**REHABILITATION, OVERLAY AND BIKE
IMPROVEMENTS ON MYRTLE AVENUE (F3K300) PM
1.55-3.77
PROJECT NO.: RPL-5904(188)
CONTRACT NO.: 221060 & 342001**

ADDENDUM NO. 1

**REHABILITATION, OVERLAY AND BIKE IMPROVEMENTS ON
 MYRTLE AVENUE (F3K300) PM 1.55-3.77
 PROJECT NO.: RPL-5904(188)
 CONTRACT NO.: 221060 & 342001**

ADDENDUM NO. 2

COUNTY OF HUMBOLDT Attachment 2 DEPARTMENT OF PUBLIC WORKS	SHEET 7 OF 13
MYRTLE AVENUE PM 1.55-2.68; 2.68-3.77	
PLAN LAYOUT STA 21+00 TO 37+00

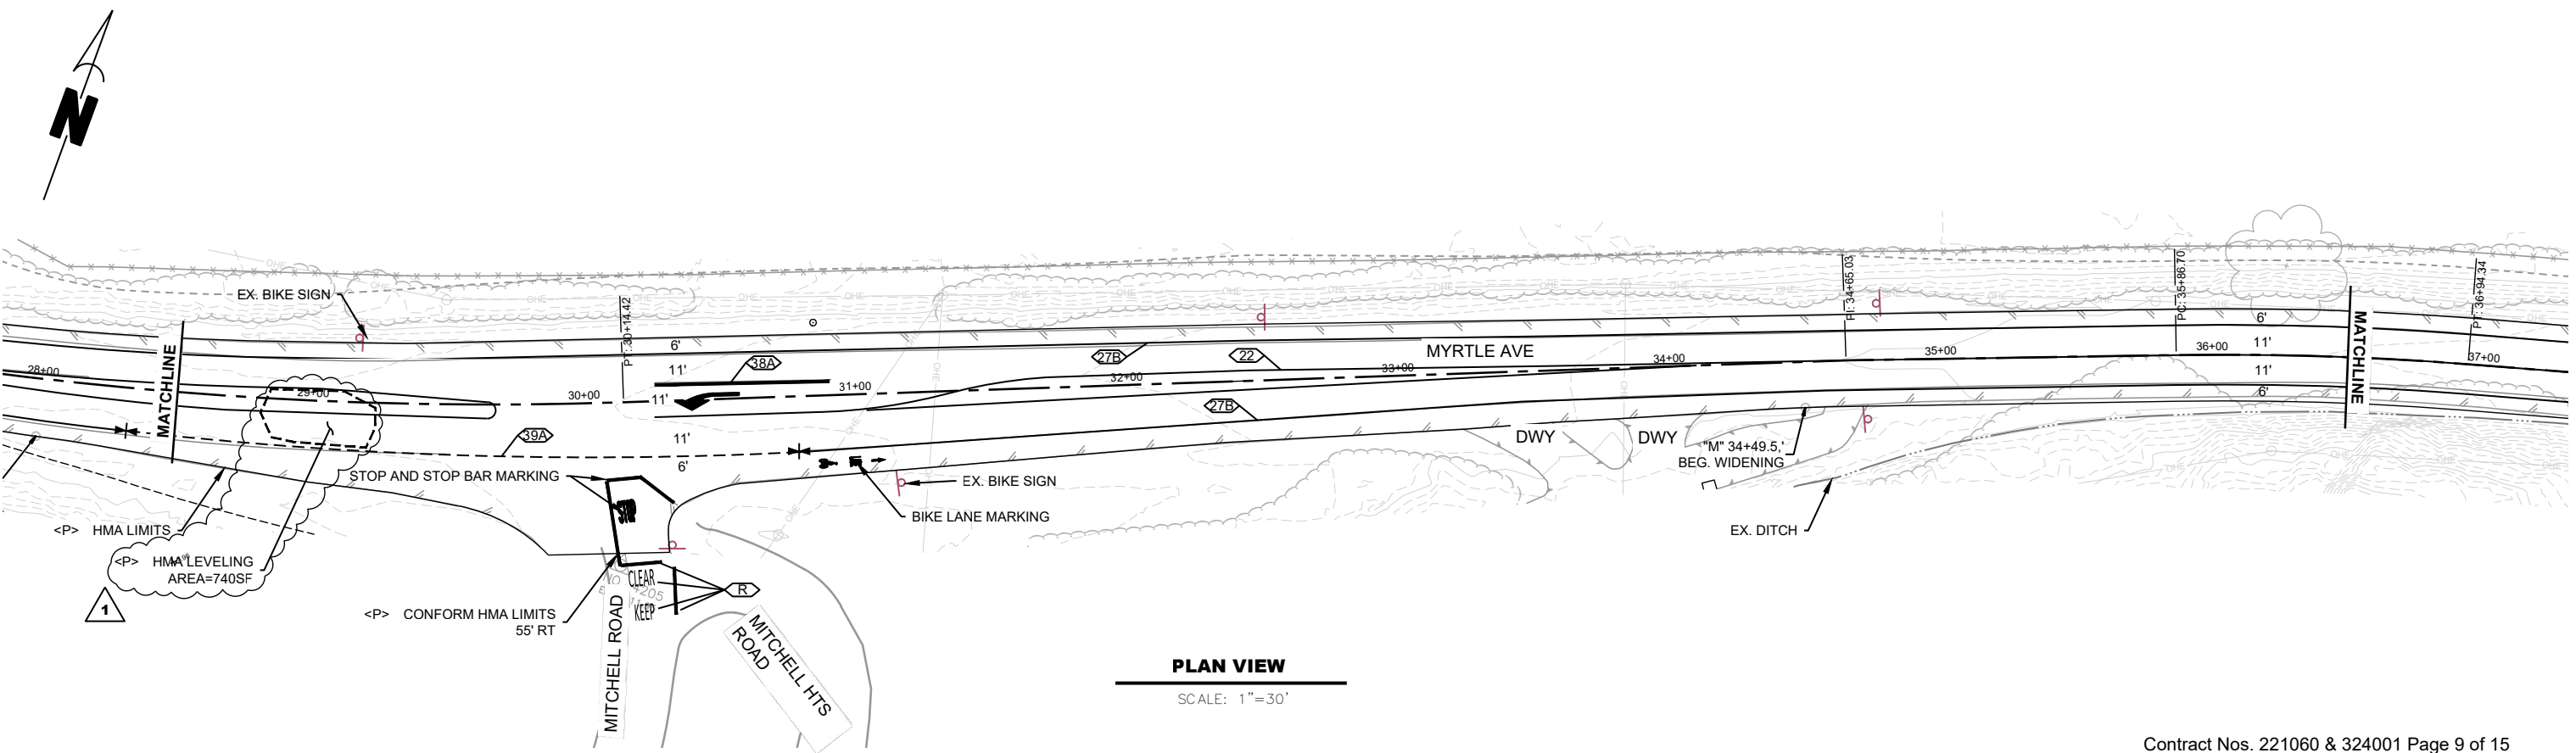
1. Contractor shall stockpile coldplane asphalt material at the staging/stockpile area located at the intersection of Freshwater Road and Myrtle Avenue. Coldplane asphalt material shall become property of the County.
2. HMA leveling shall be placed near station 29+00 right lane (Area=740sf) and at 57+00 right shoulder/driveway (Area=415sf). The purpose for HMA leveling is to improve drainage at the two locations. Revised Plan Sheets 7 and 9 show the approximate location and limits of HMA Leveling.
3. The Daylight Line for structure excavation of the curb-gutter and gabion is added to Revised Plan Sheet 9.
4. The Supplemental Project Information table listed in Section 2-1.06B of the Special Provisions shall include "Myrtle Avenue (F3K300) PM 1.55-3.77_C Line Profile_Supplemental_2026-03-24.pdf."
